**MONITORING YEAR 5  
ANNUAL REPORT**  
Final

**BUCKWATER BUFFER MITIGATION SITE**

Orange County, NC  
NCDEQ Contract No. 006829  
DMS Project Number 97084  
NCDWR Project Number 2016-0406v1

RE: DMS Comments on the MY5 Report  
Buckwater, Project ID #97084, DMS Contract 6829

### Graph 1. Vegetation Plot Trends

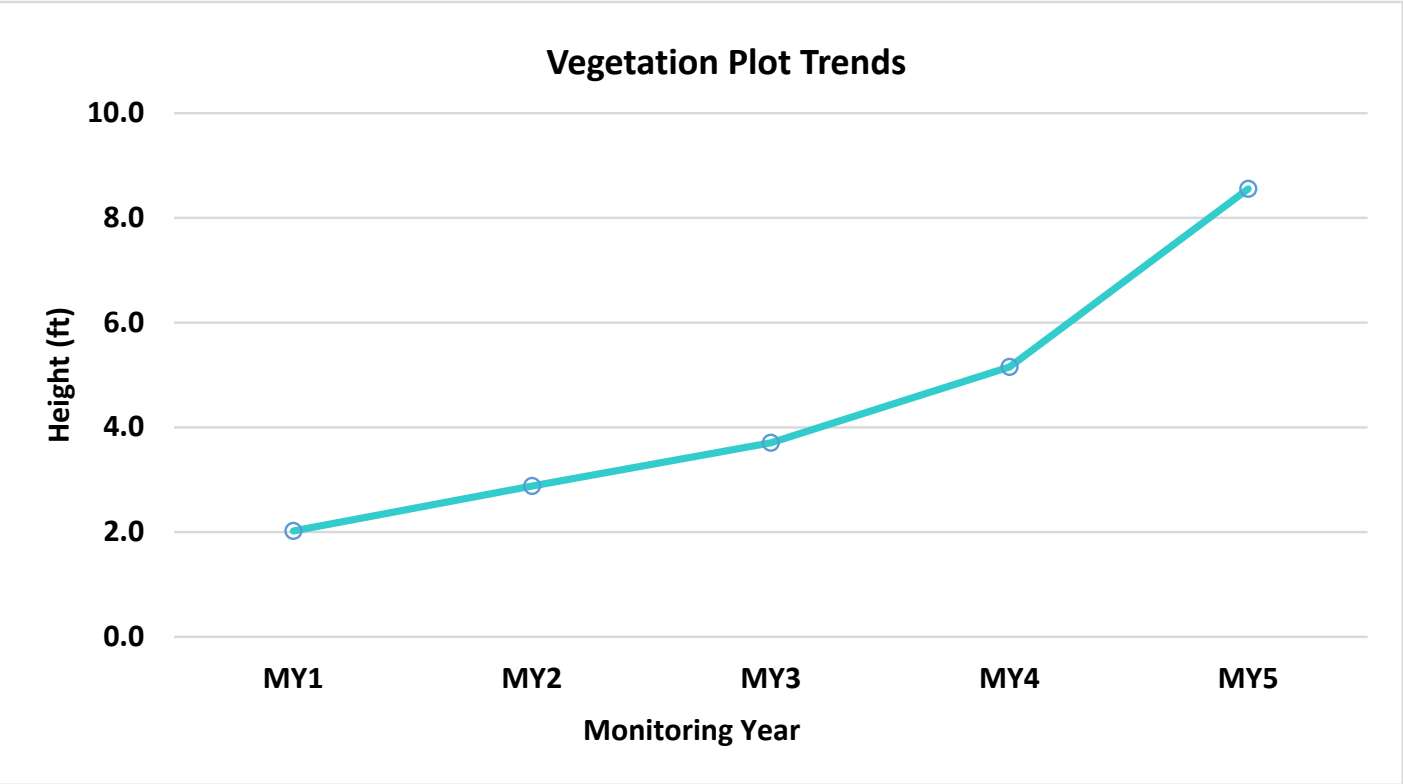
2. While individual heights are included, it may be useful for DWR's review to include average tree height for each veg plot, and site wide (recommend an additional column in Table 8), since the buffer portion of the site will be proposed for closeout this year.

*Response: Table 8b: Average Vegetation Height by Plot and Graph 1: Vegetation Plot Trends are now included in the report.*
